Re: ZC Case No. 12-15--Gallaudet University Campus Plan and Further Processing--Applicant's Response to DDOT Comments

Re: Gallaudet University 2022 Campus Plan Supplemental TIS Memorandum

Figure 10: Pedestrian Signage

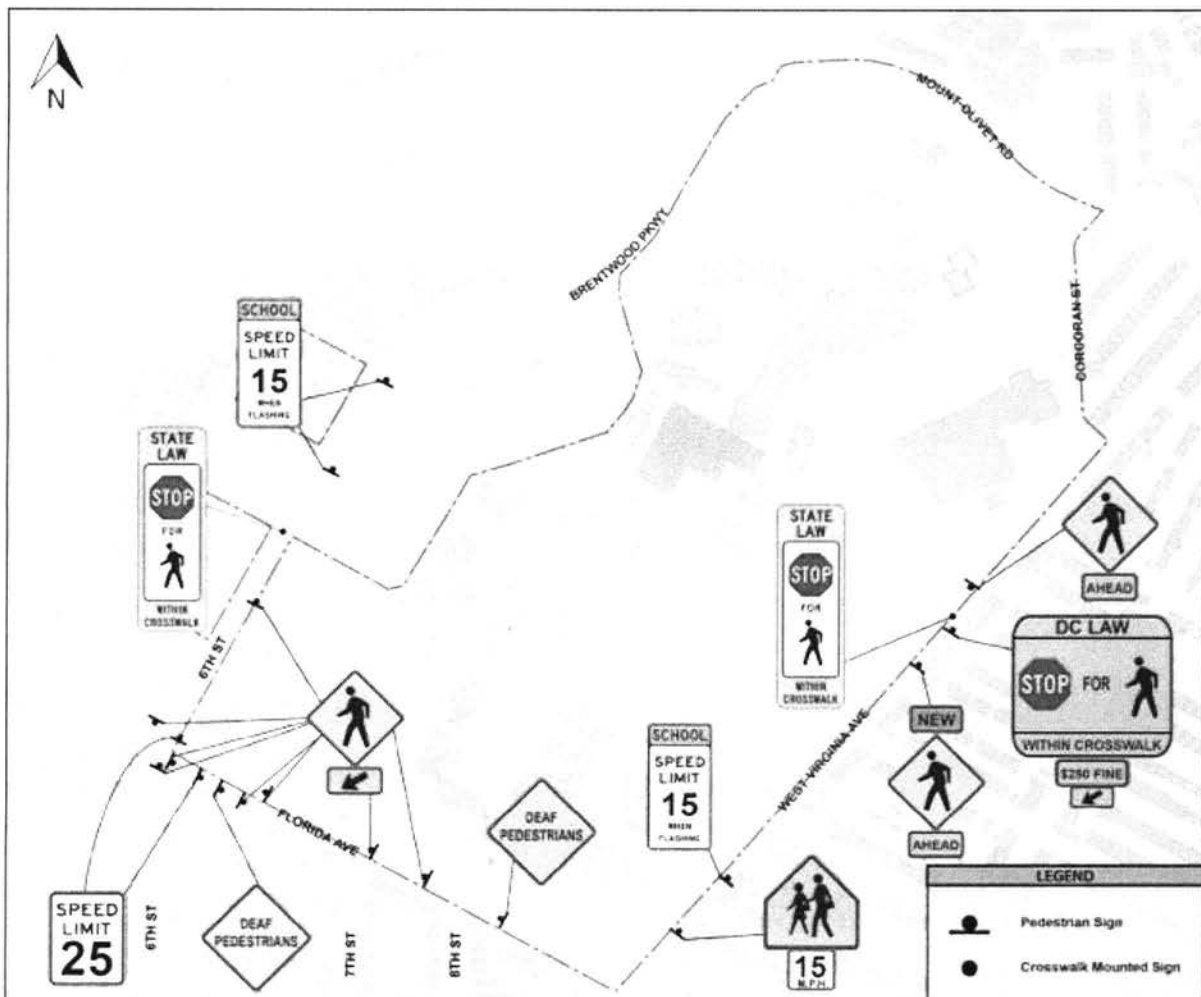
A number of pedestrian related signs are stationed in the study area. Signage is primarily located along 6th Street, Florida Avenue, and along West Virginia Avenue. The signage varies from warning/yield signs to alerts drivers of pedestrians crossing at crosswalks to signs that notify drivers of the hard of hearing population that may be present in the area. Figure 10, illustrates the various types of signs located within the study area.
